HISTORIC AND DESIGN REVIEW COMMISSION March 21, 2018

HDRC CASE NO: 2018-097 808 E CARSON **ADDRESS:** NCB 1266 BLK 2 LOT 2 **LEGAL DESCRIPTION: ZONING:** R-6, H **CITY COUNCIL DIST.:** 2 **DISTRICT:** Government Hill Historic District **APPLICANT:** Pegy Brimhall **OWNER:** 808 E Carson, LLC Construction of two, two story residential structures **TYPE OF WORK:** February 22, 2018 **APPLICATION RECEIVED:** April 23, 2018 **60-DAY REVIEW:**

The applicant is requesting conceptual approval to construct two, two story, multi-family residential structures on the vacant lot at 808 E Carson.

Sheet Contents: Building 1 Elevations

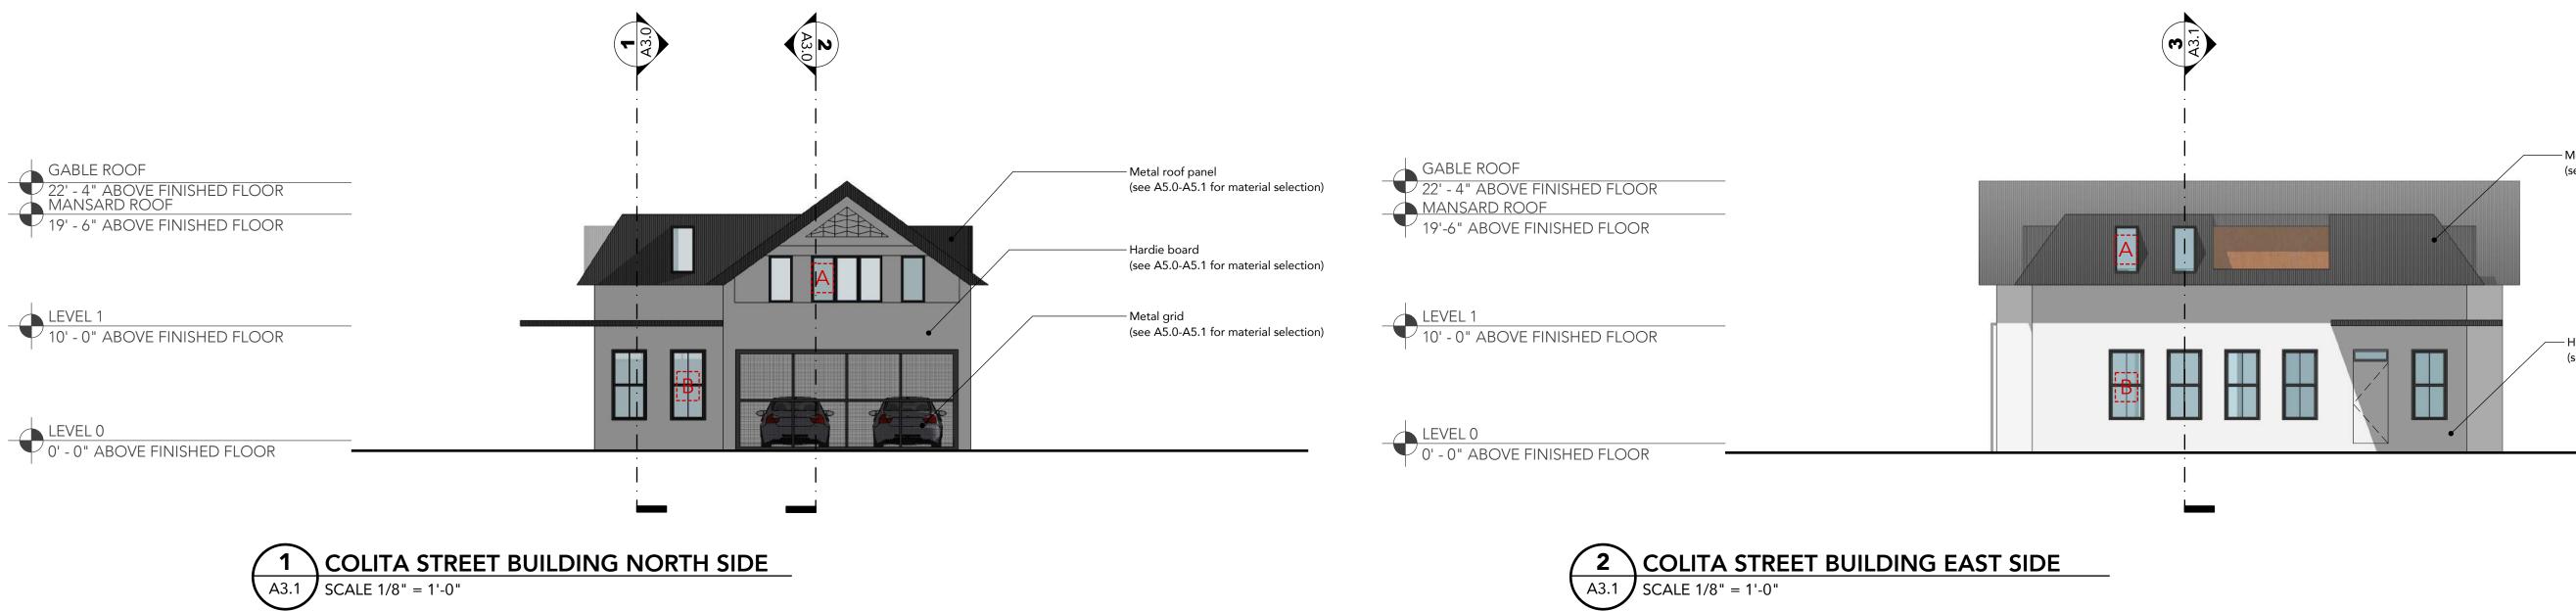
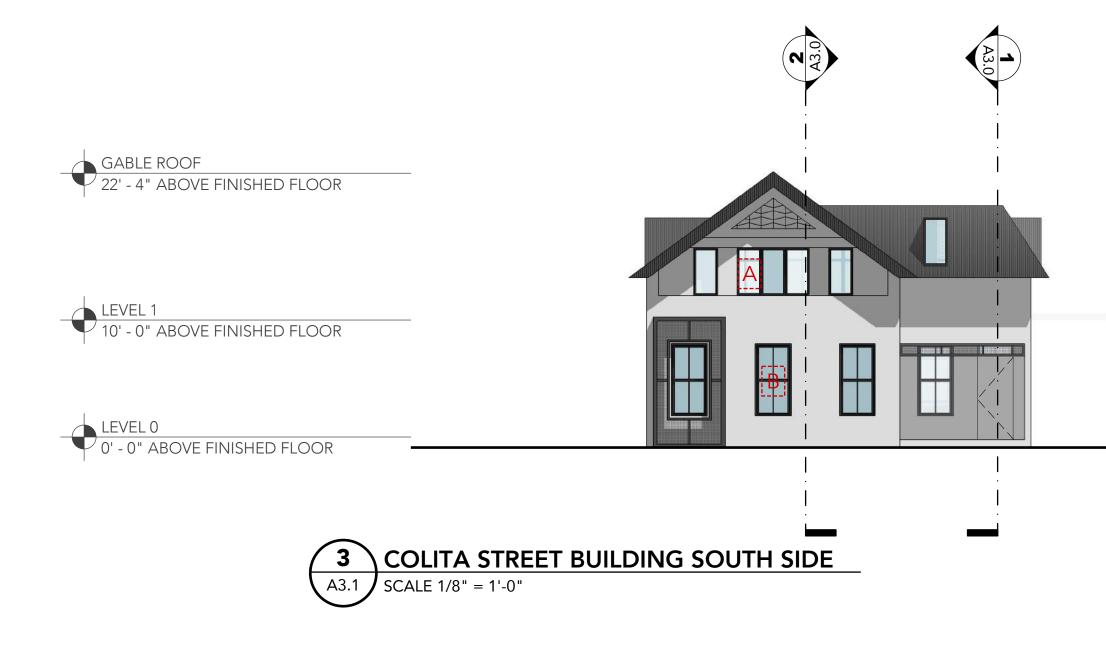
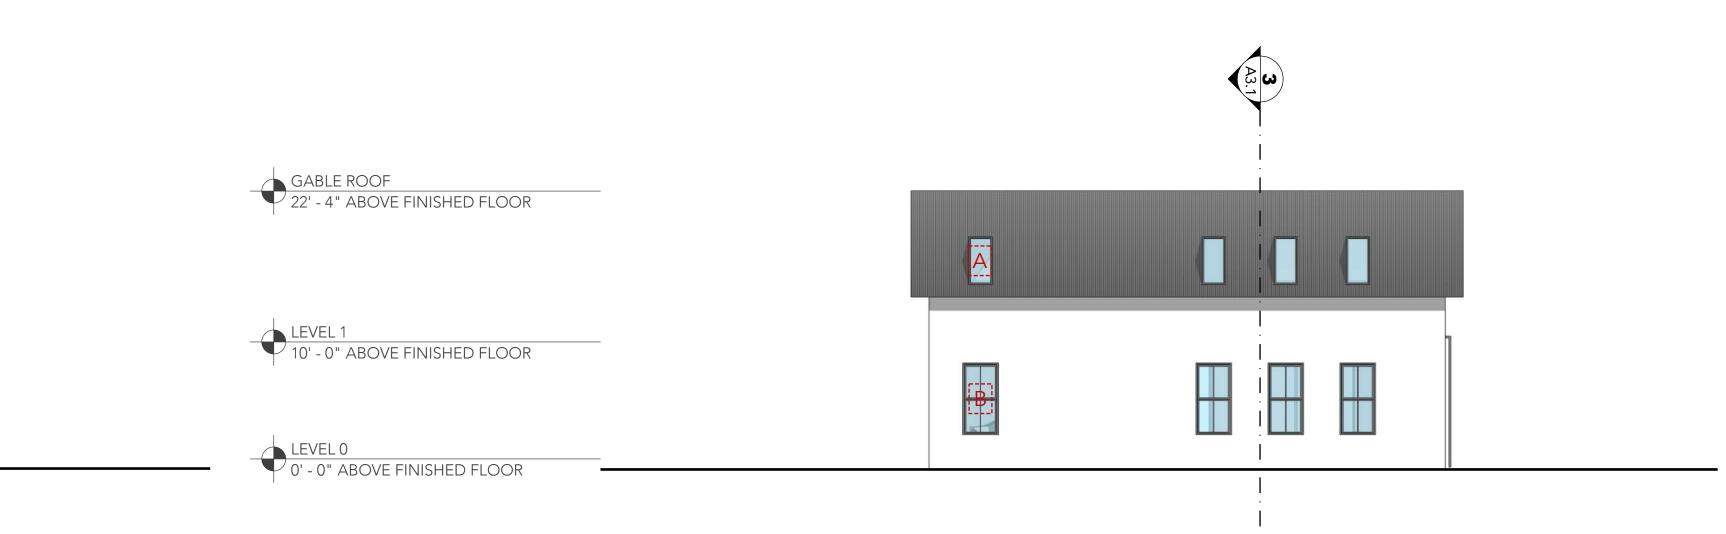
- f. SCALE & MASS (E Carson) Per the Guidelines for New Construction 2.A.i., a height and massing similar to historic structures in the vicinity of the proposed new construction should be used. In residential districts, the height and scale of new construction should not exceed that of the majority of historic buildings by more than one-story. This block of E Carson features seven residential structures, three of which feature two stories in height. While there are examples of historic structures nearby that feature multiple stories in height, the proposed new construction features a total height of 32' 4" (E Carson structure). Staff finds the proposed height of the structure to address E Carson inconsistent with the Guidelines. Additionally, the proposed massing features solid wall planes at locations where historic structures feature voids for porches.

- j. ROOF FORM The applicant has proposed for the roof form to be raised over the head height of the proposed balconies forming a façade arrangement that is not common for structures in the district. Staff finds that the proposed roof form should originate lower on the second level's façade.

- o. ARCHITECTURAL DETAILS (PORCHES) The proposed new construction does not feature porch massing, a primary architectural element of Folk Victorian architecture. Staff finds this to be inappropriate and inconsistent with the Guidelines. Additionally, in regards to porches, the adjacent structures on the lot feature porches that compromise a large portion of the structures ground level footprint and massing. Without the incorporation of porches, the proposed massing is inconsistent with that found in the district and on neighboring Folk Victorian Structures.

- i. That porches or porch like elements should be incorporated as noted in finding e.
- ii. That the proposed roof height should be lowered as noted in findings f and j.
- iii. That porches should be included to be recessed behind protruding bays as noted in finding n.
- iv. That the applicant continue to develop materials with the specifications noted in finding m.
